23-07 MILL AND OVERLAY ALPINE DRIVE

NEIGHBORHOOD OVERLAY IMPROVEMENTS  
 NO. (23-07)  
 CITY OF RAMSEY, MINNESOTA

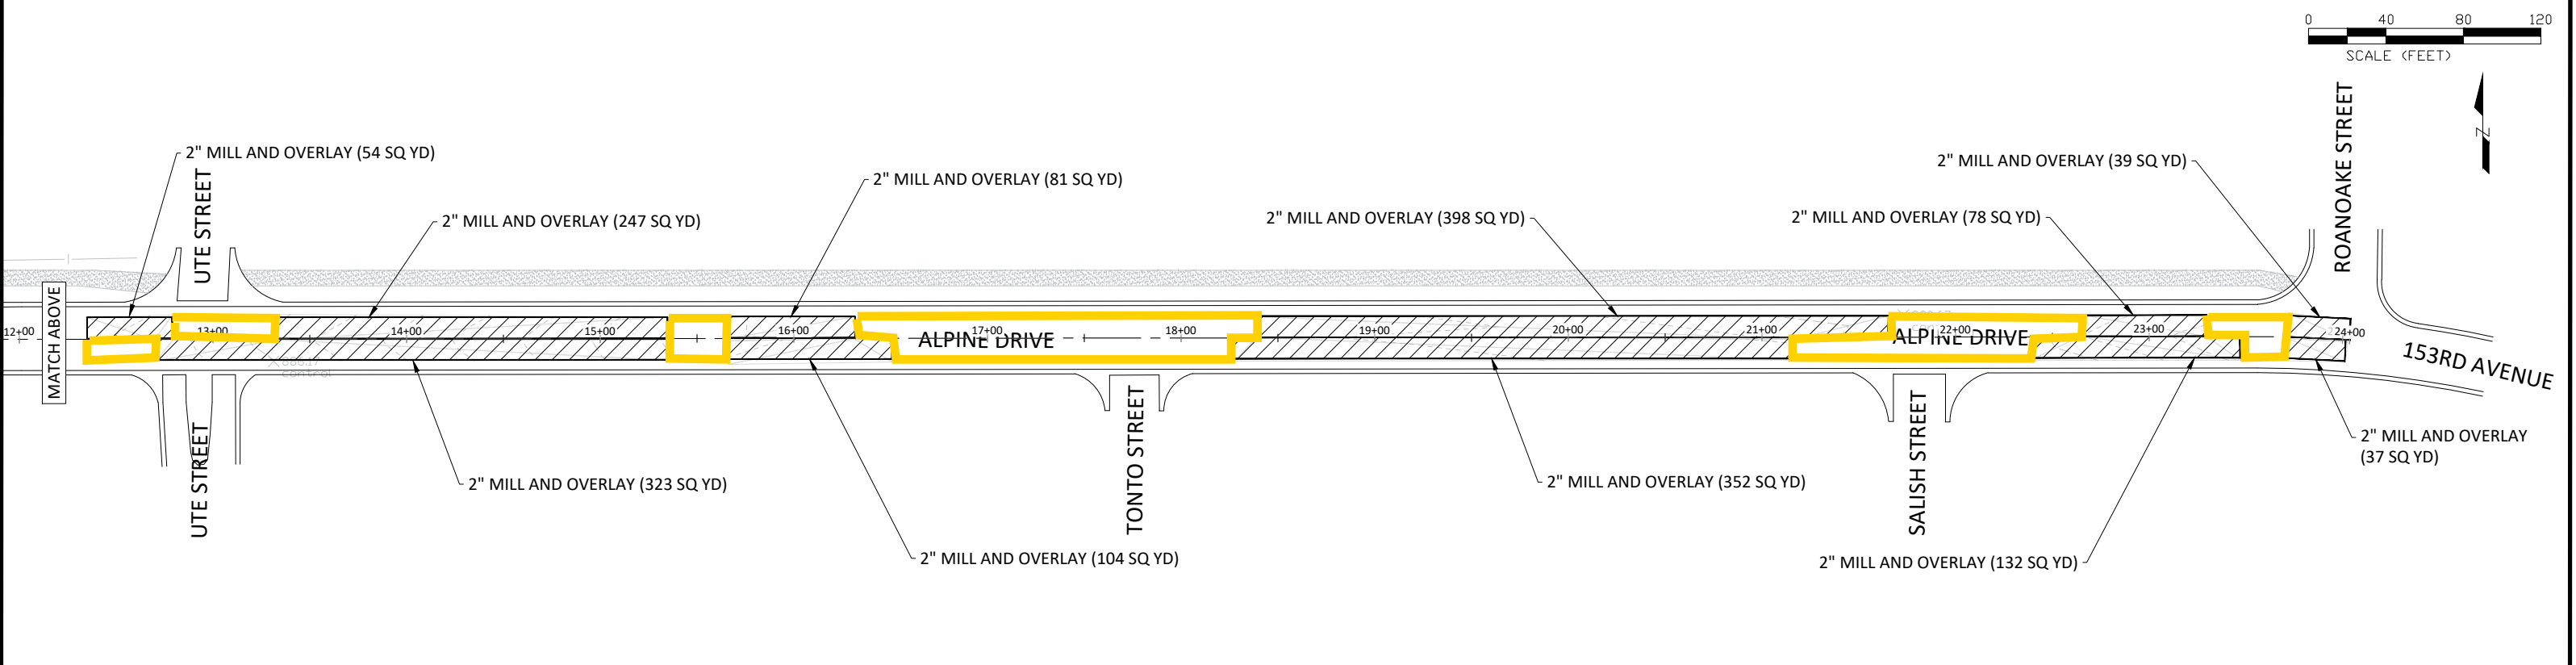
DATE	REVISION
04/14/23	ADDED 2" MILL AND OVERLAY TO ALPINE DRIVE
